Historic Preservation Commission Meeting

January 07, 2026

LOT 51 - BLUE CRAB PRIVATE
RESIDENCE

Cover letter addressing plan review comments for COFA-09-25-019927
Lot 51,4 Blue Crab Road – Tabby Roads

1 SITE PLAN
A1.0 1/8" = 1'-0"

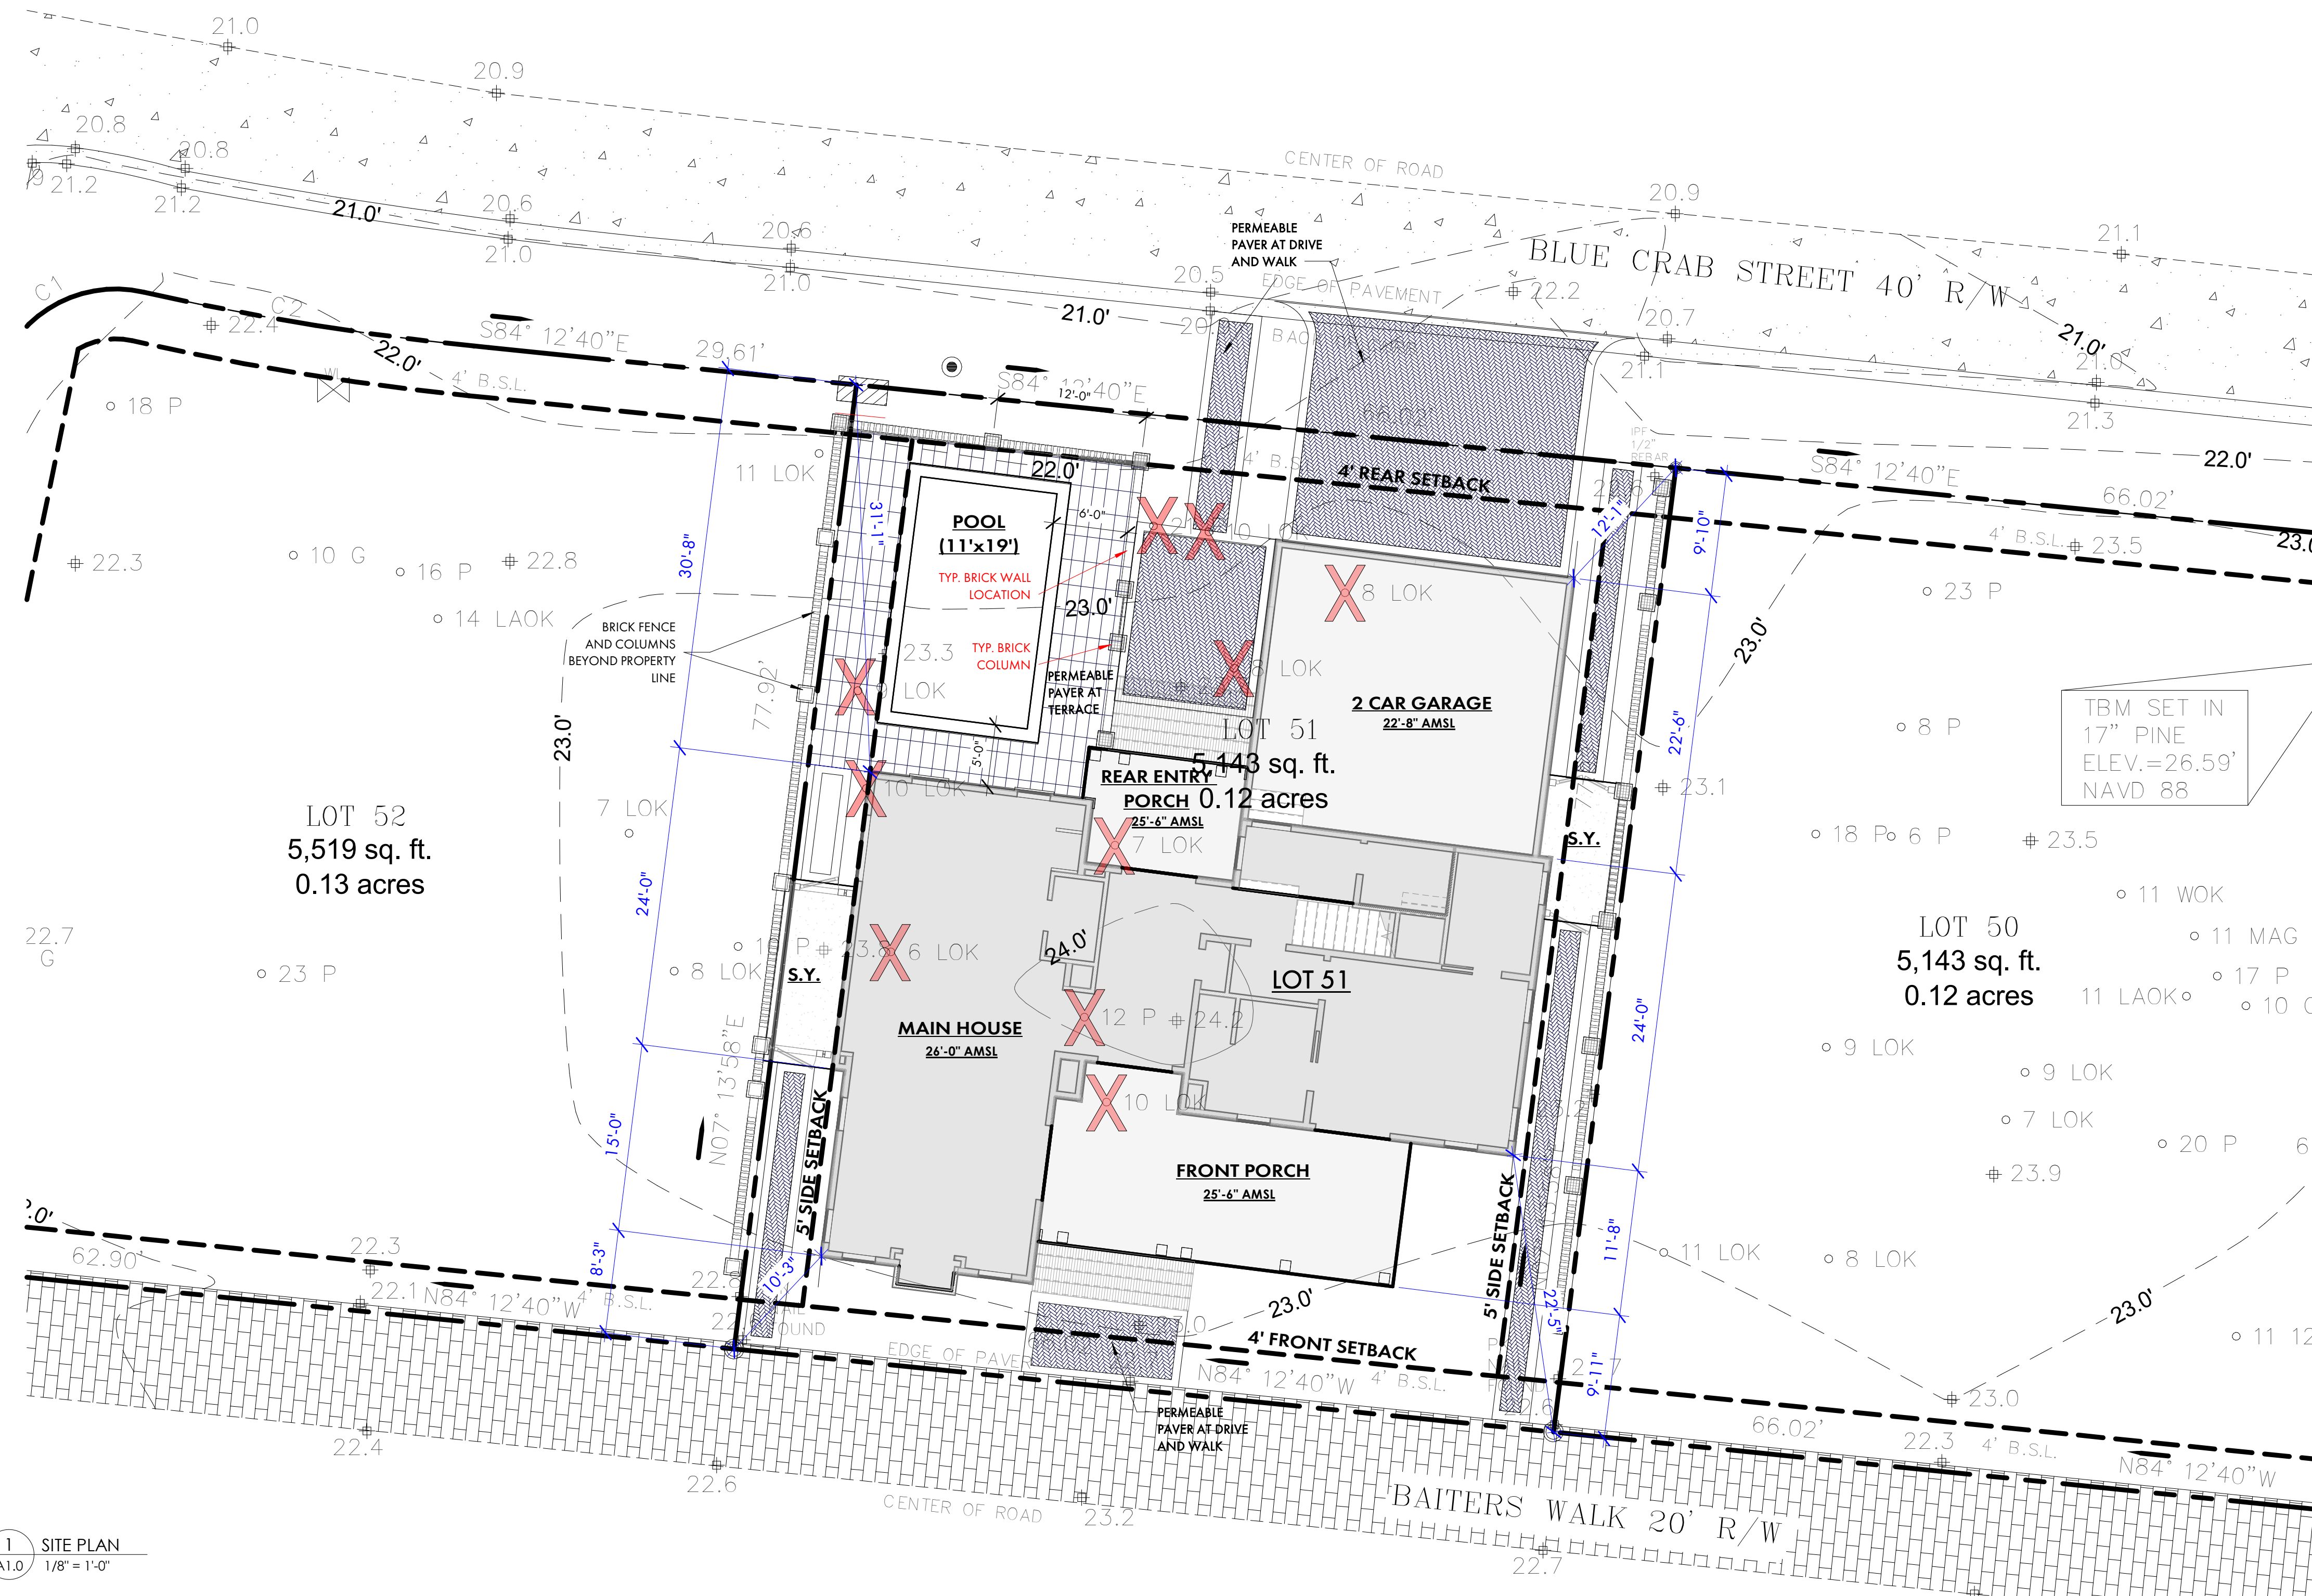
2. Setbacks: Show the front and rear yard setback on the Composite Site Plan and the individual Site Plan.

7. On-street Parking: At the pre-application meeting, we discussed removal of the proposed on-street parking spaces. Was the plan not updated, or is it the intent to provide them? The Site Plan (P.02) and Sheet A2.1 do not match.

- **All setbacks are now shown on the site plan and composite site plans**

- We have omitted the on-street parking from the site plans as discussed

A4.0

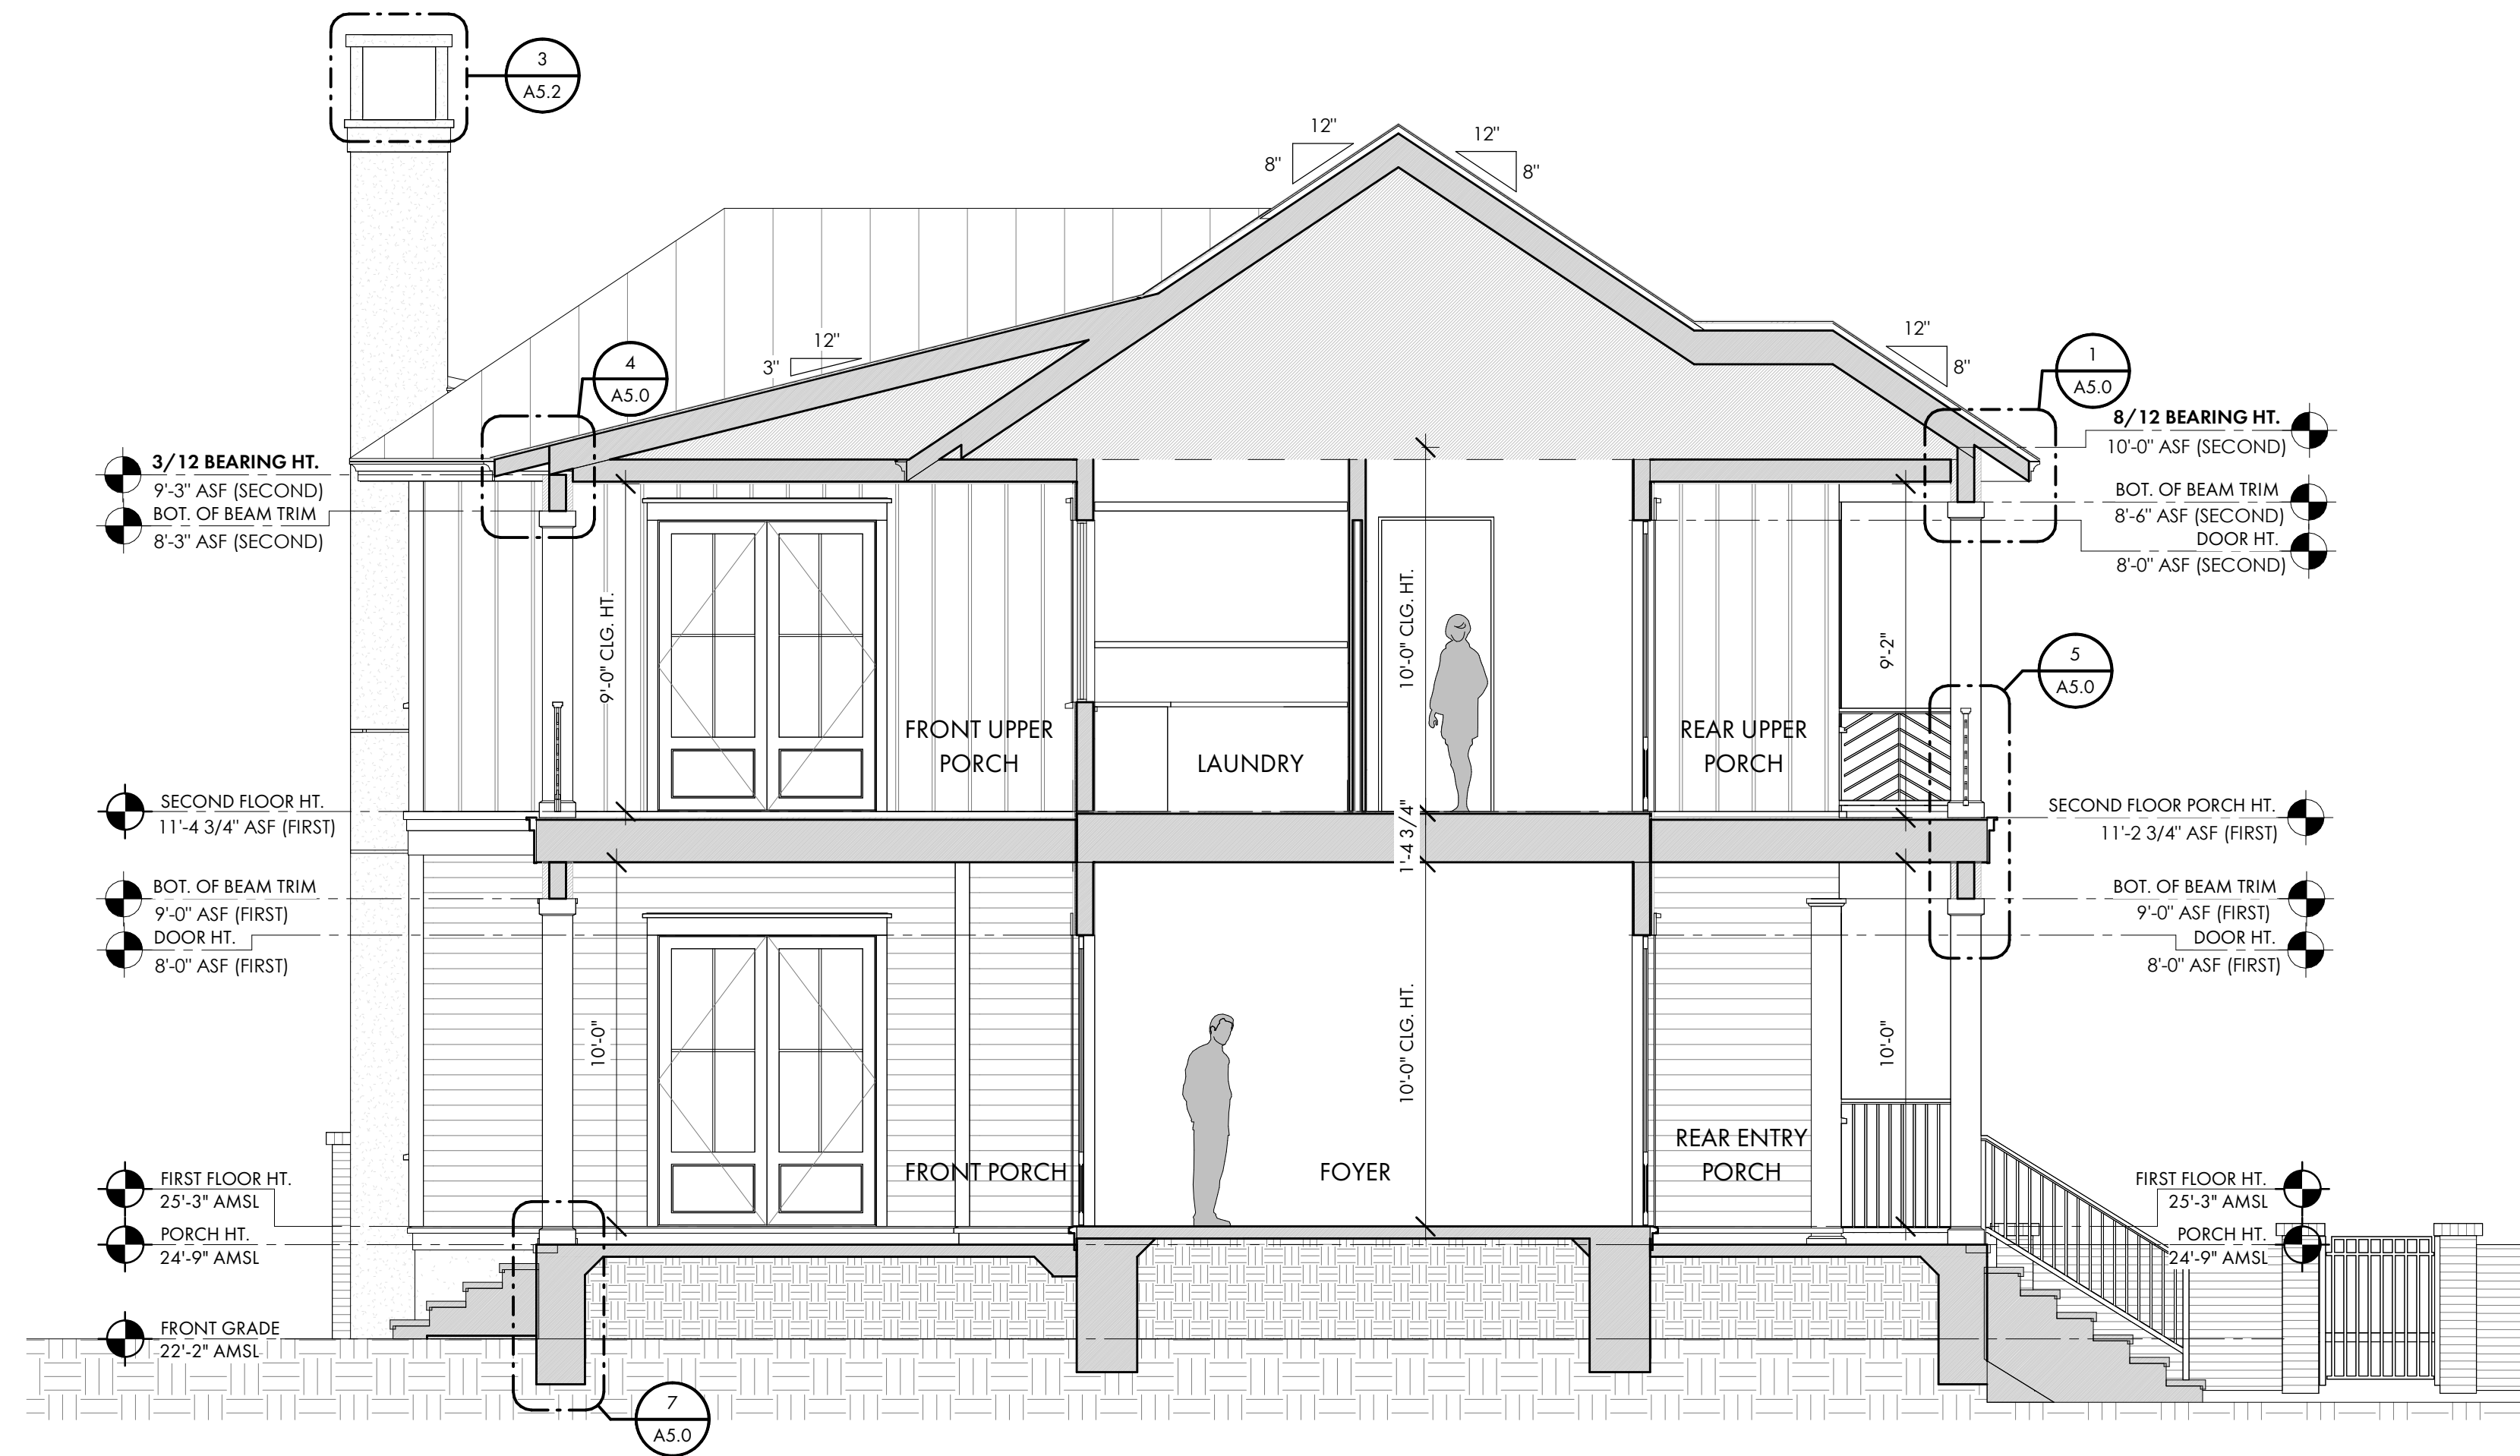
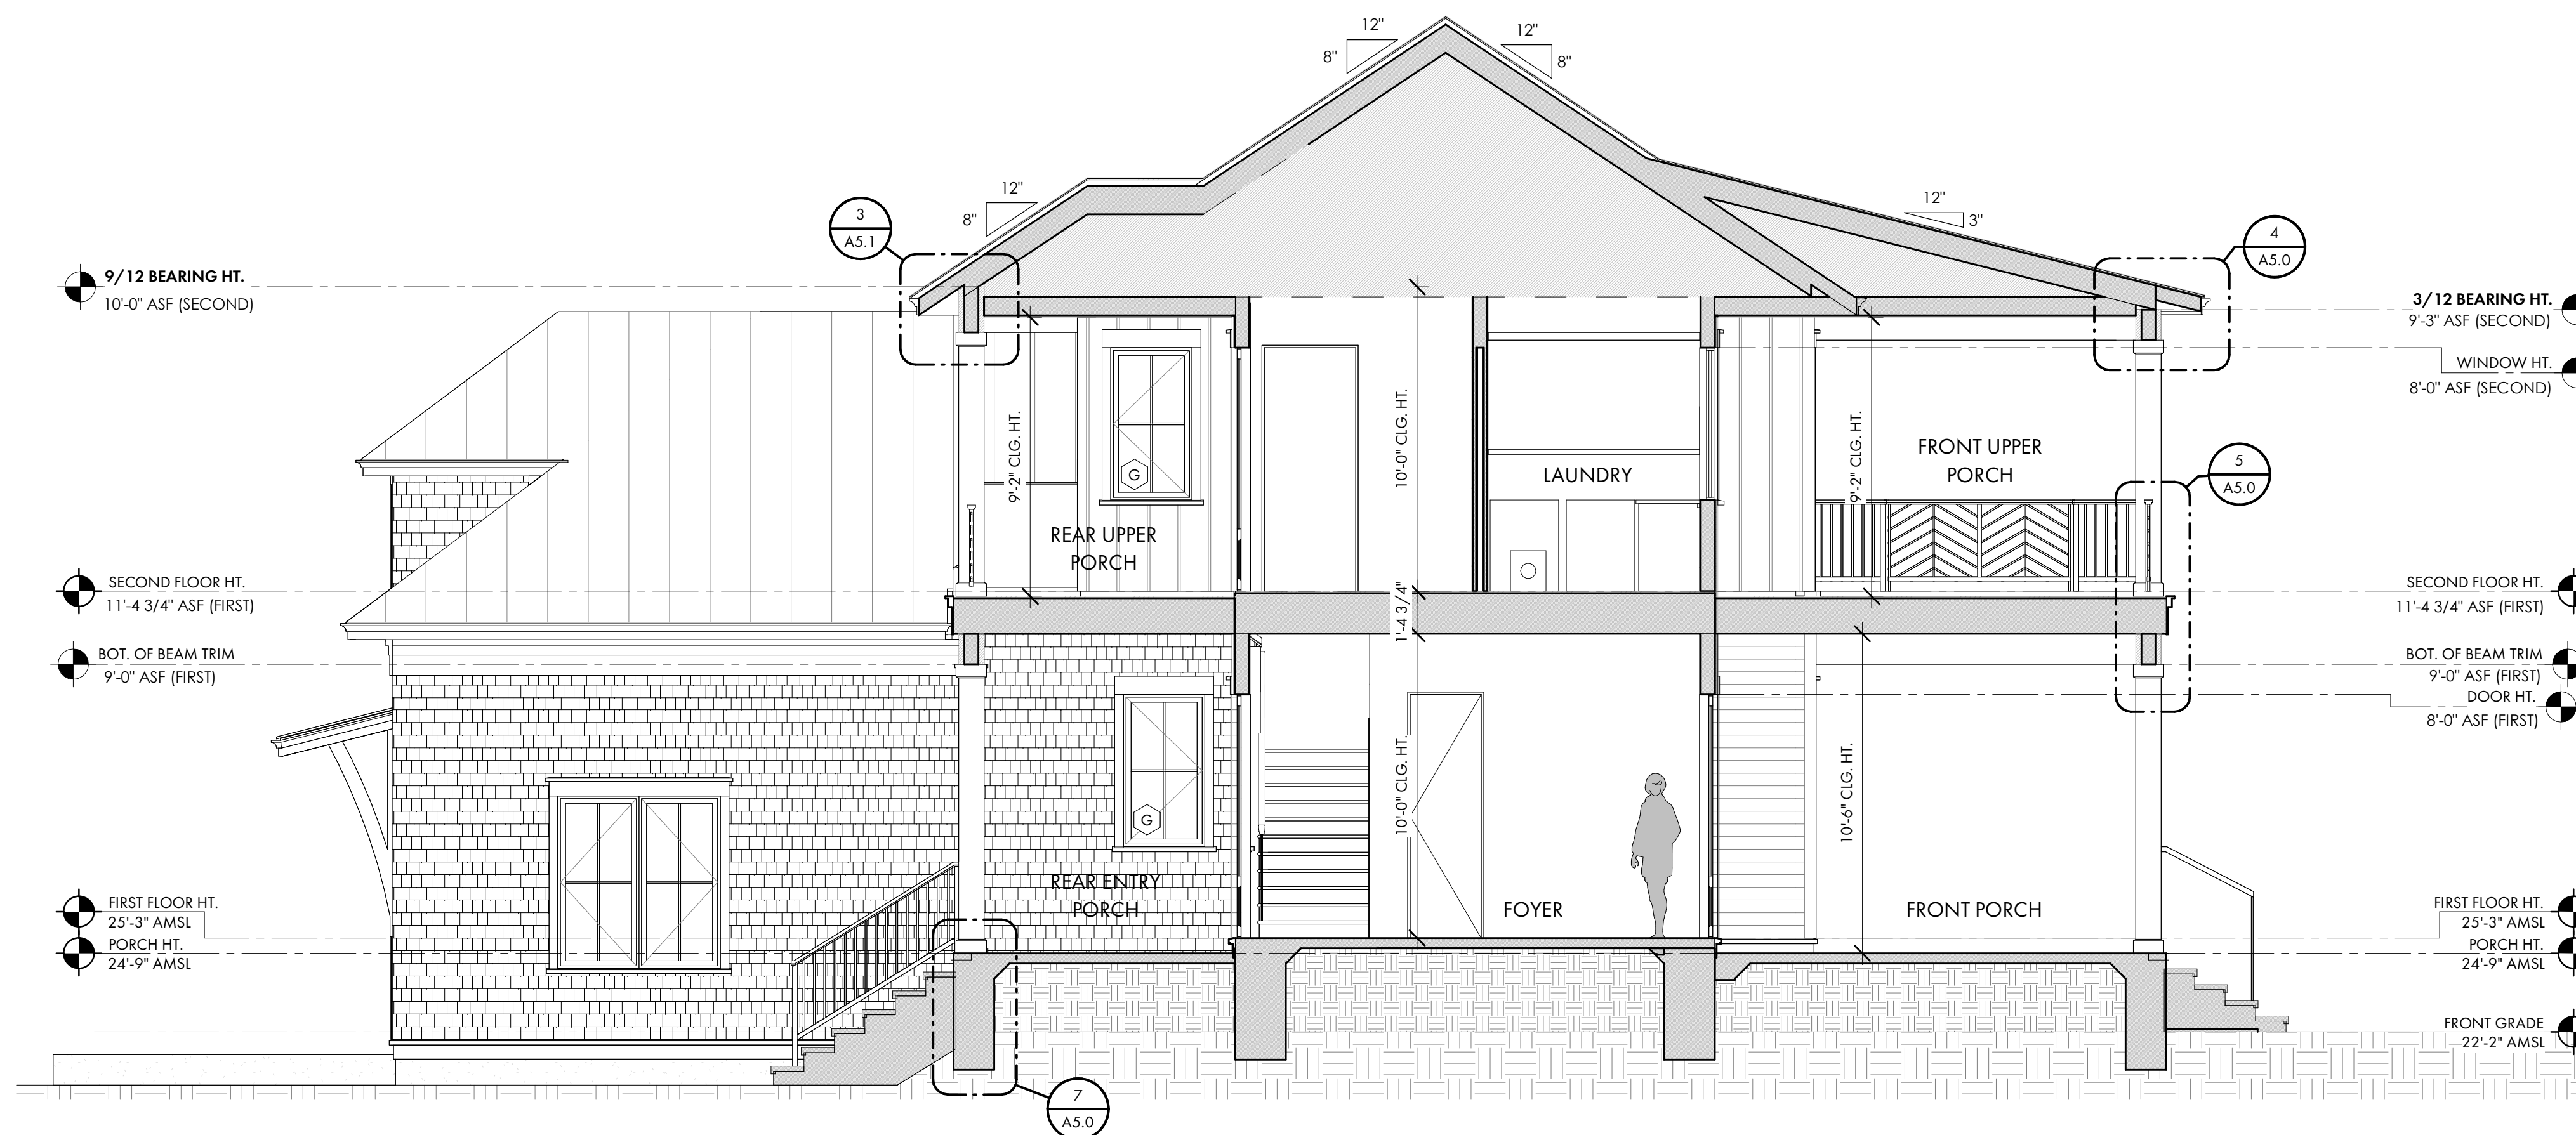
10. Rear Double Porch Detail: Show the interior elevations of the porch that are not visible.

- Please see accompanying building sections on sheet A4.0 and A4.1 showing interior areas of the porches
